# SERVICE BULLETIN

No. 741

Piper Aircraft Corporation

PART I: Wing Flap Travel Restriction and Inspection of Wing Flap Flexible Drive Shaft

SKETCH A

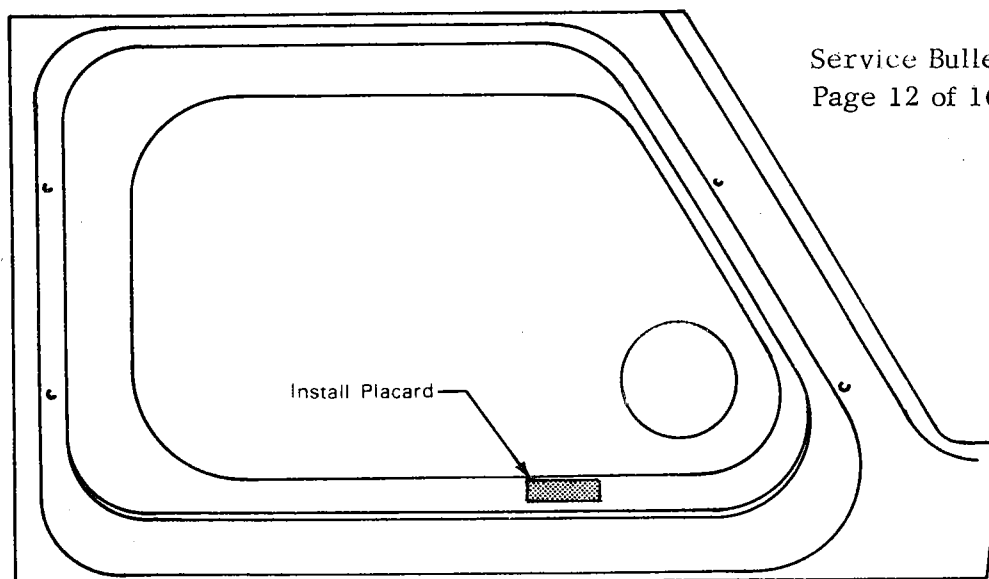
3. Paint a red full flap radial position mark to correspond with the needle position at 15° on the flap position indicator lens. Extend the red radial line to the instrument bezel as a slip mark (Sketch A).
4. Attach the Flap Restriction Placard to the left window moulding in full view of the pilot (Sketch B).
5. Attach the Stall Speed Placard(s) adjacent to the airspeed indicator(s) (Sketch C).
6. Make the necessary handwritten changes in pen and ink to the Pilot's Operating Manual/AFM as follows (until installation of Piper Kit 764 398, after which refer to PART II, Instruction 2.(a) (i):  
Approved Airplane Flight Manual per Report No. 1740 for Model PA-31T Serial Nos. 31T-7400002 through 31T-7520013

SKETCH B

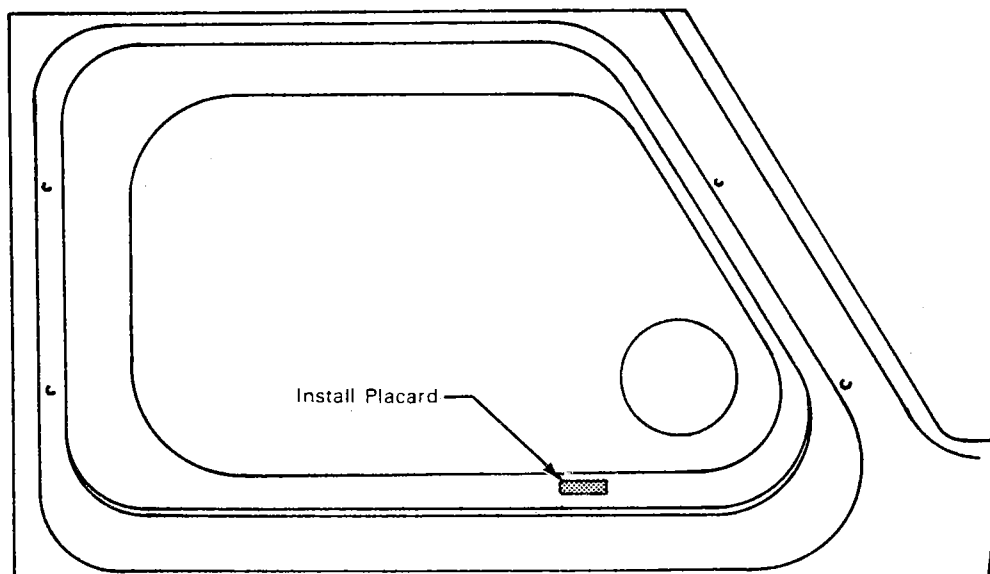
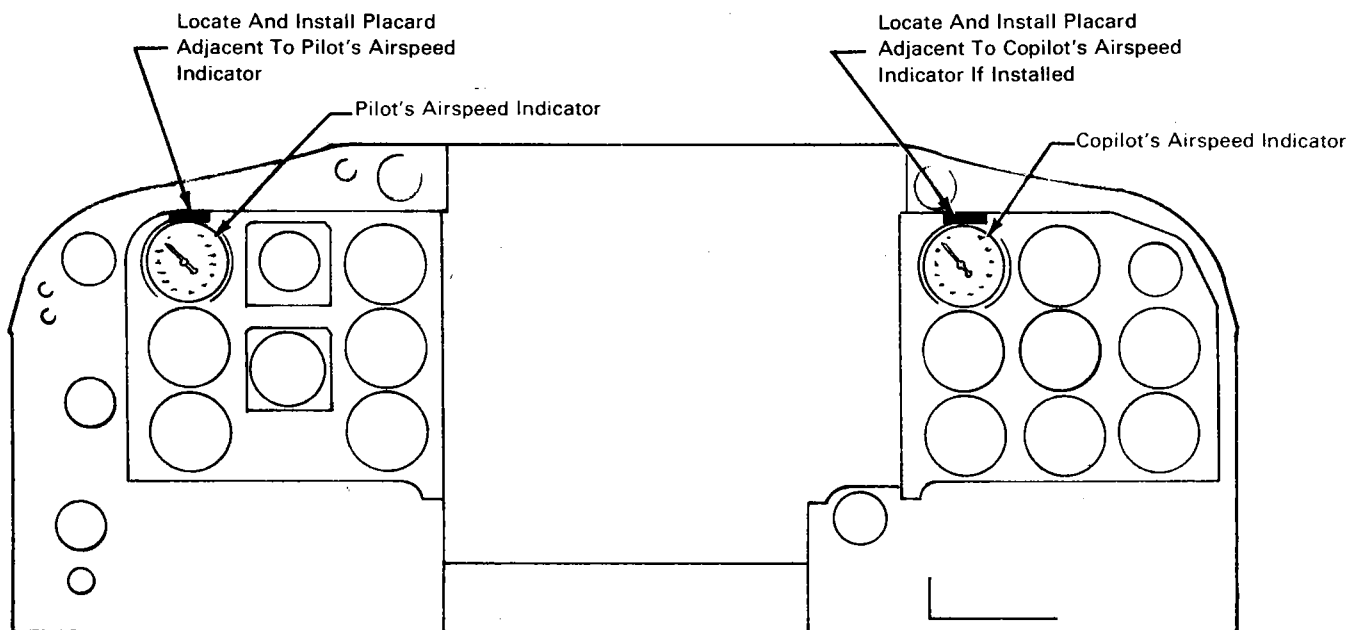
- Attach Autopilot/Flap Operating Placard, to the pilots left window moulding in full view of the pilot (Refer to Sketch B).
- Make necessary handwritten changes in pen and ink to the appropriate Airplane Flight Manual/Pilot's Operating Manuals/Pilot's Operating Handbook as follows:
  - For Piper Model PA-31T Cheyenne
    - Approved Airplane Flight Manual per Report No. 1740 for Model PA-31T, Serial Nos. 31T-7520014 through 31T-7620057. (And Ser.Nos. 31T-7400002 through 31T-7520013 only if Piper Kit 764 398 is installed.)  
Page 3-vii                      Log of Revisions. Add: Interim Revision 12 IAW  
Piper Service Bulletin No. 741.

FIGURE 2

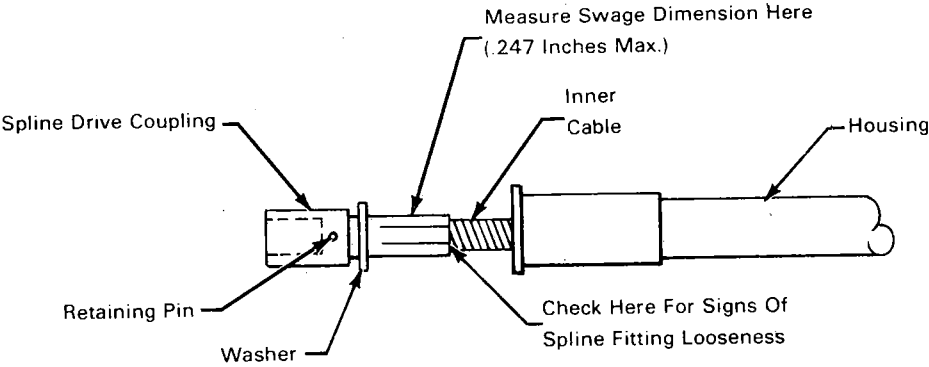
4. Visually inspect the flexible shaft splined drive coupling and retaining pin for evidence of looseness on the cable swage fitting. (Ref. Sketch D, Figure 2.)

5. Inspect the swaged fittings at both ends of the flexible shaft as follows:
  - a. Expose the swaged portion of the inner cable at the motor end by twisting the outer housing two (2) turns clockwise. The swaged portion of the cable should have eight (8) flats clearly visible and free from deep scratches or wear marks. (Ref. Sketch D, Figure 2.)

FIGURE 1

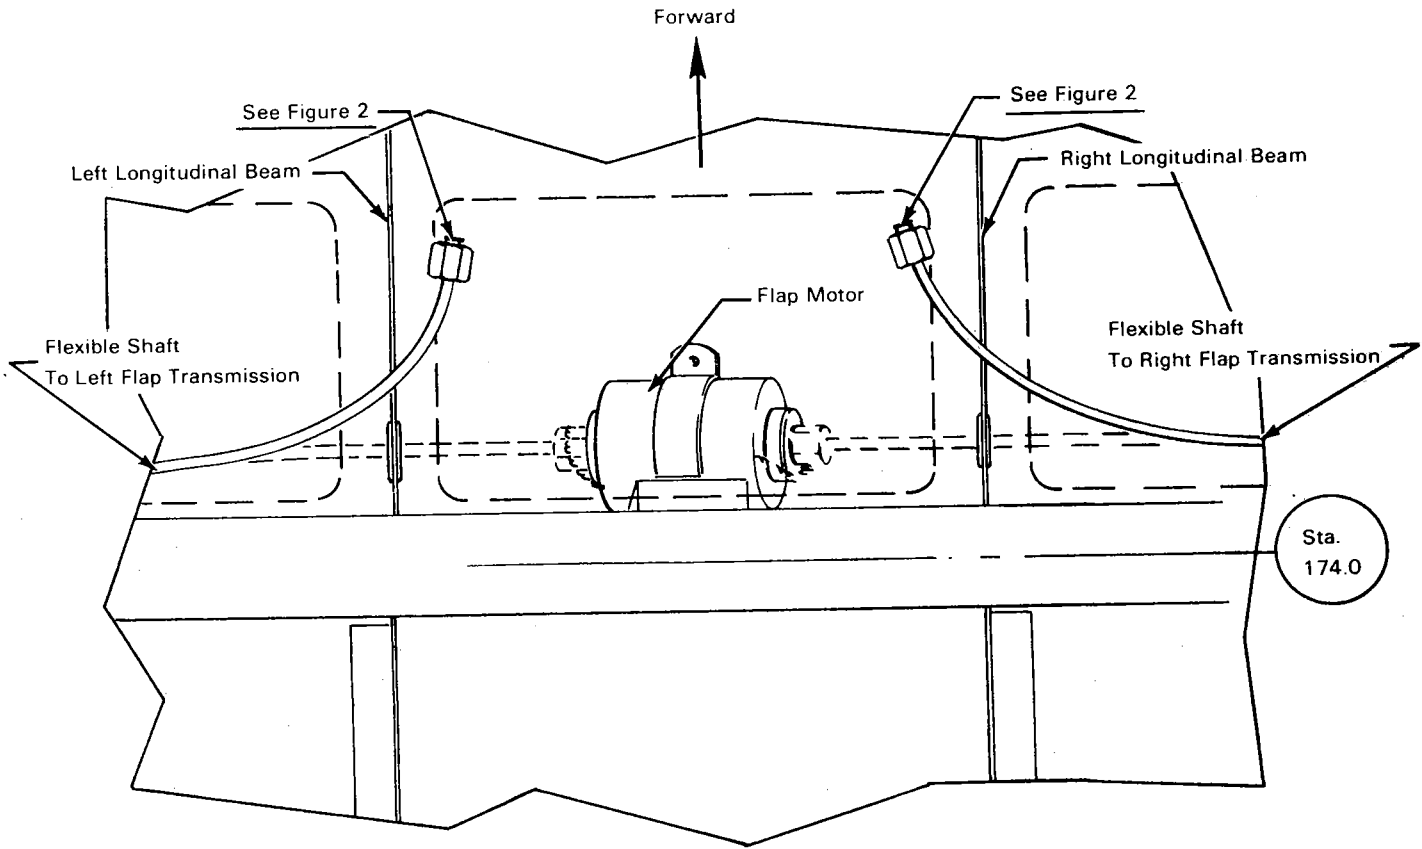
- B. 3. Disconnect flexible shafts and remove the flap motor. Using caution not to damage the flexible shaft housing, route the flexible shafts outboard through the longitudinal beams (Ref Sketch D).

FIGURE 4

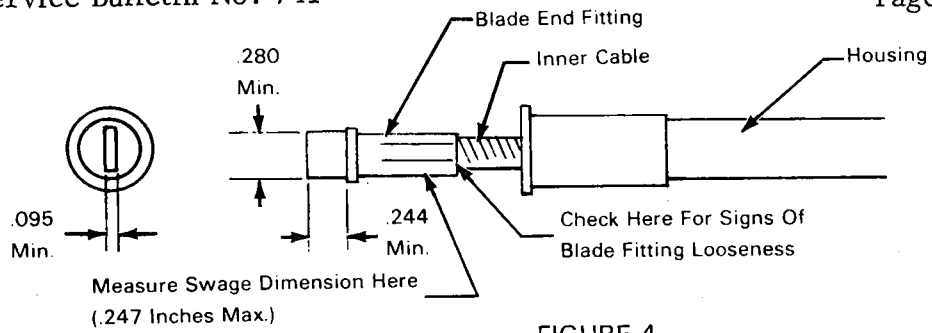
- d. Inspect the drive blade dimension as shown in Sketch E, Figure 4.
6. Inspect the internal splines of the drive coupling for evidence of wear. If splines are distorted or significantly worn, replace the drive shaft. Use the following method to determine if the amount of spline wear is acceptable.

SKETCH E

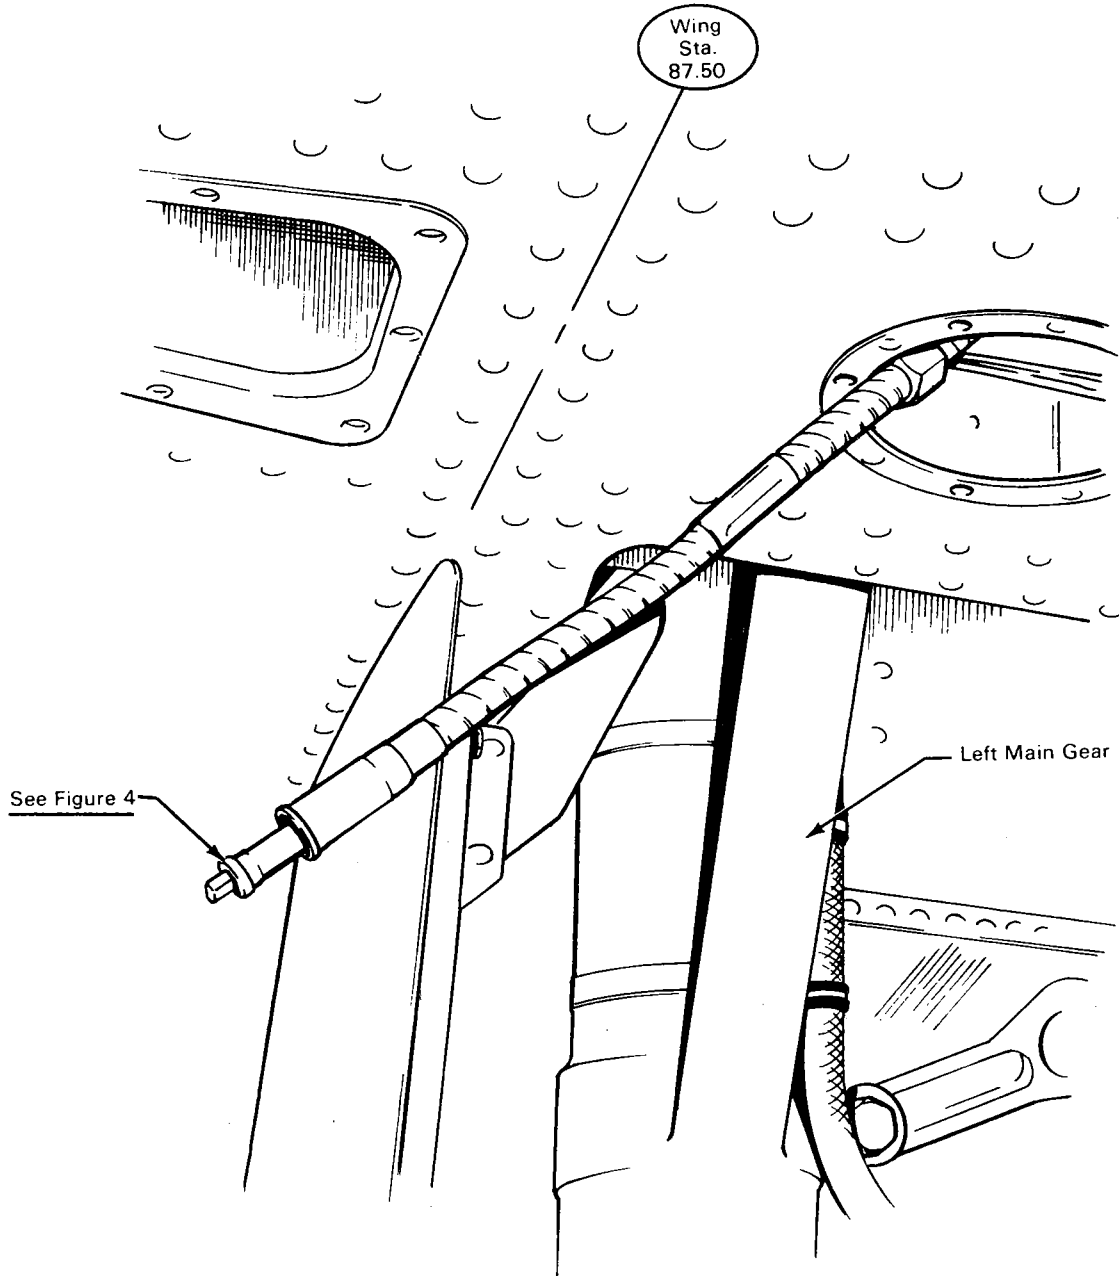
- c. Disconnect drive shaft from the flap transmission. Using caution not to damage the shaft housing, route inboard through the Sta. 87.50 bulkhead. (Ref Sketch E.) Inspect the swaged portion of the drive blade fitting end as described in "a" and "b" above.

7. While holding the transmission end of the drive shaft stationary, twist the motor end one (1) turn clockwise and release. Inspect for evidence of movement between the inner cable and the swaged fittings at both ends. Turn cable one (1) turn counter-clockwise and repeat inspection. (Ref. Sketch D, E.) If movement or separation between the inner cable and the swage fitting is apparent, replace the flexible shaft assembly.

FIGURE 6

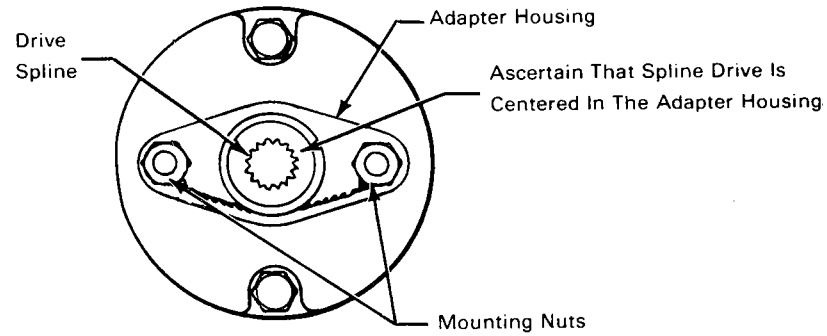
9. Reassembly of the flap system:
- Ascertain that the flap motor shaft is centered within the motor adapter housing (Ref. Sketch F, Figure 6.).
  - Lubricate both ends of the flexible shafts with MIL-G-23827 grease.

FIGURE 5

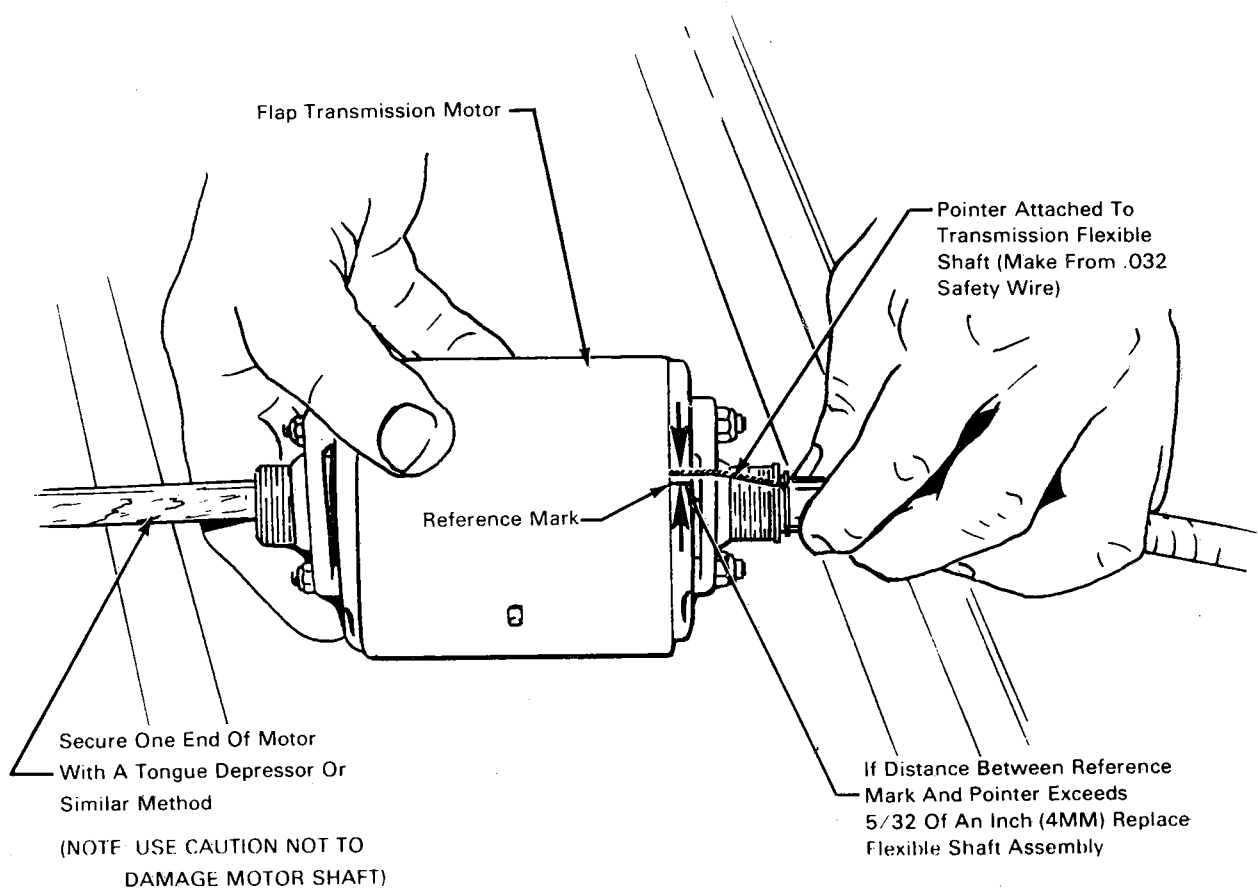
- a. Twist a piece of .032 safety wire around the swaged fitting at the motor end of the drive shaft to form a pointer (Ref Sketch F, Figure 5). With one end of the flap motor armature shaft secured engage the opposite end into the flexible shaft spline.

- b. Hold the spline end of the flexible shaft securely with one hand, and gently turn the flap motor to remove rotational play in the splines. Place a reference mark on the motor housing adjacent to the wire pointer (Ref Sketch F, Figure 5). Turn the flap motor gently in the opposite direction to remove rotational play and place another reference mark on the motor housing. If the distance between these two marks exceed 5/32 of an inch (4 mm) replace the flexible shaft assembly (Ref Sketch F, Figure 5).
